Historic Preservation Commission

~ Agenda ~

Tuesday, May 9, 2023

III. Case Z06555-032323 Watauga County Parking Deck - Modified COA

EXTERIOR ELEVATIONS

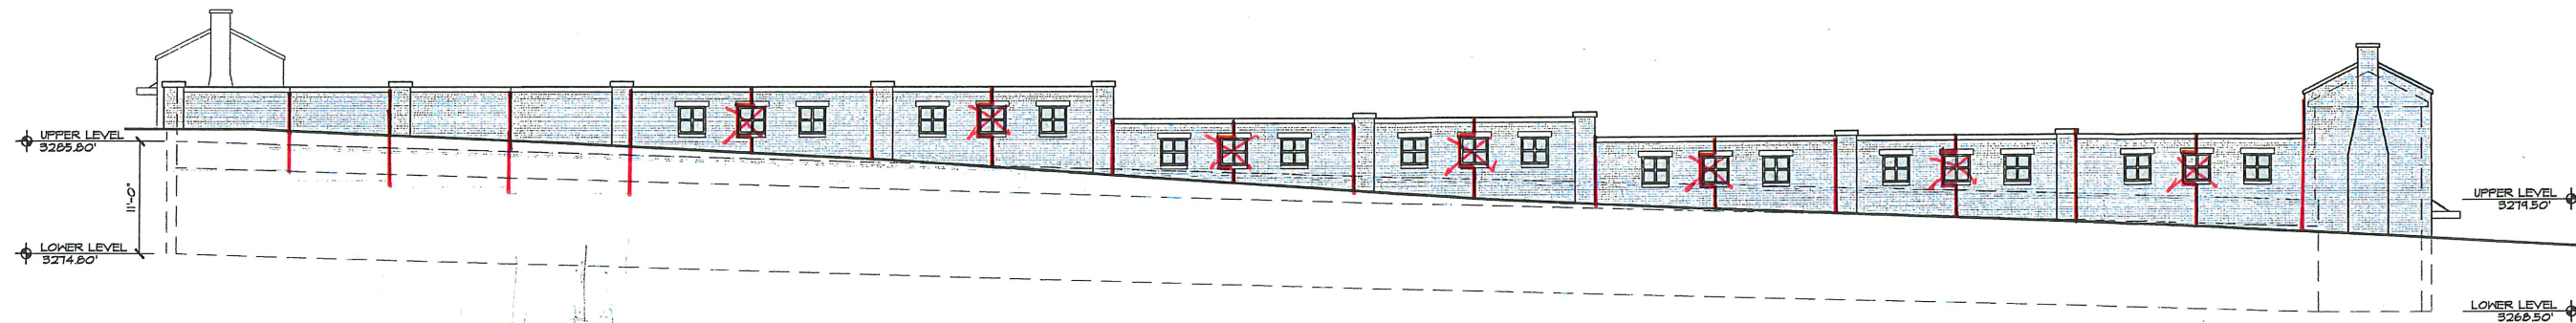
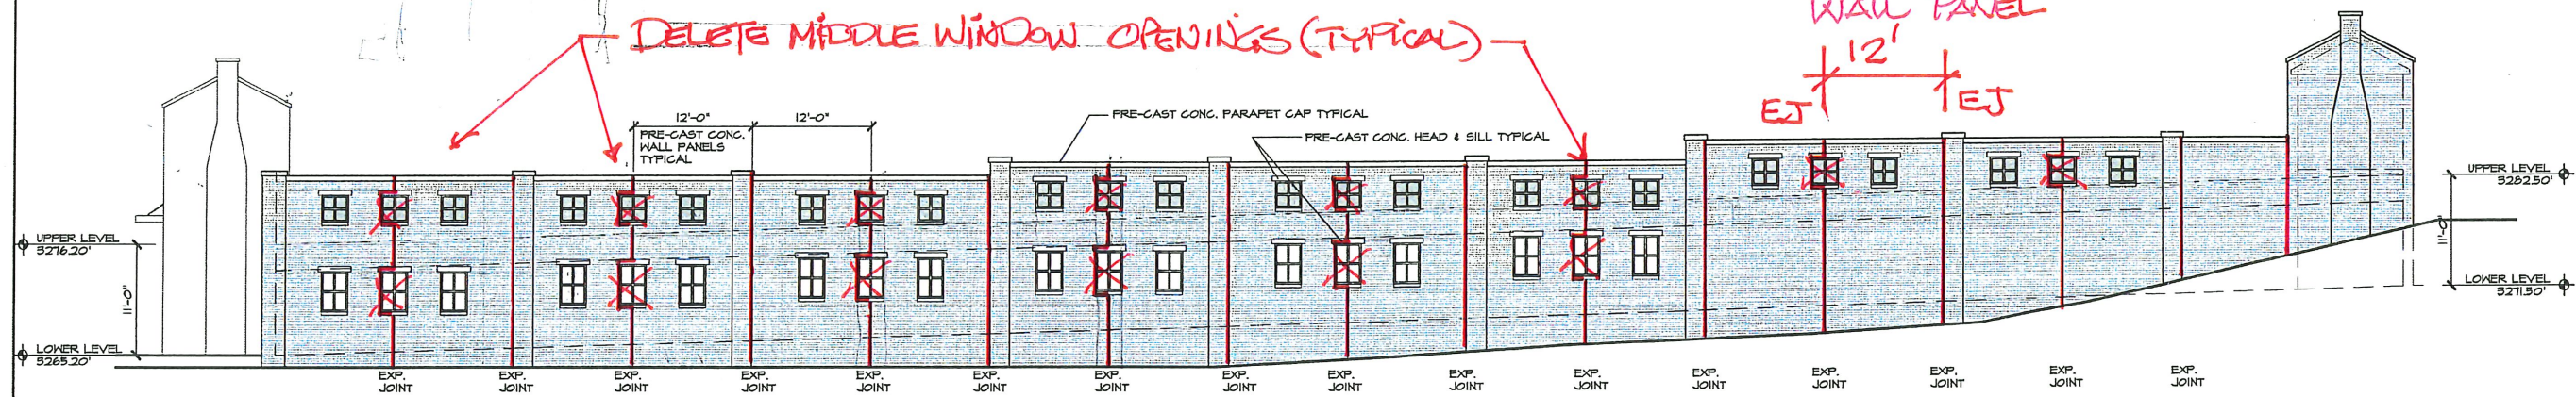
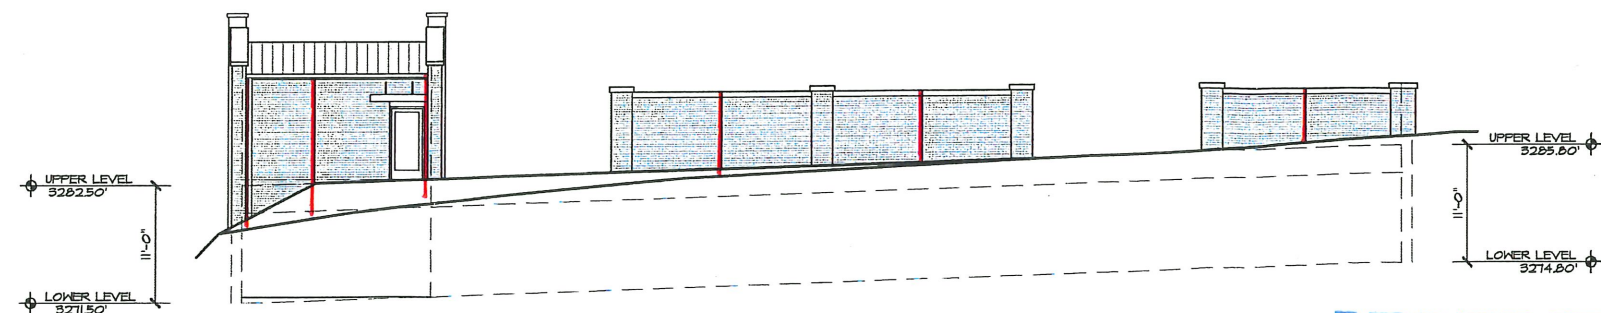
Request to modify the original August 9, 2022 COA to allow a change of exterior materials from true brick veneer to Thin-set brick in Precast concrete wall panel system and reduce number of "window openings" from 90 to 61.

- Where there is a conflict between the application information, and the revised elevations (March 23, 2023), the plans control. Insignificant deviations may be permitted to comply with the requirements of the UDO.
- Any commitments and representations concerning the proposed exterior modification made by the applicant or its (his or her) representatives at the public hearing shall also become a condition of the permit, and a basis for a stop work order and/or permit revocation if violated.
- The applicant shall submit the necessary applications, plans, details and specifications which meet the requirements of the Town Code, UDO, Building Code and any other applicable codes for review and approval necessary to issue Zoning and Building Permits.

1. Any previous condition not modified by the revised elevations (March 23, 2023) remains applicable including:
 - a. The applicant shall meet the lighting standards set forth at Section 7 of the Design Standards for Historic Streetscapes, Landscapes, Monuments, and Other Resources in the District, UDO Appendix D. In meeting these lighting standards, the goal shall be to minimize the number and visibility of the fixtures, and in particular to avoid or minimize poles that are visible from the outside of the structure. Staff shall review the lighting plan submission, and if Staff has significant questions as to compliance with Section 7, the applicant agrees that the case will be brought back HPC for further review and approval of the lighting plan.

- b. The faux chimneys on the stair buildings shall not to exceed the height shown on the revised plans, and may be modified consistent with any of the examples that the applicant showed the HPC during the August 9, 2022 meeting.
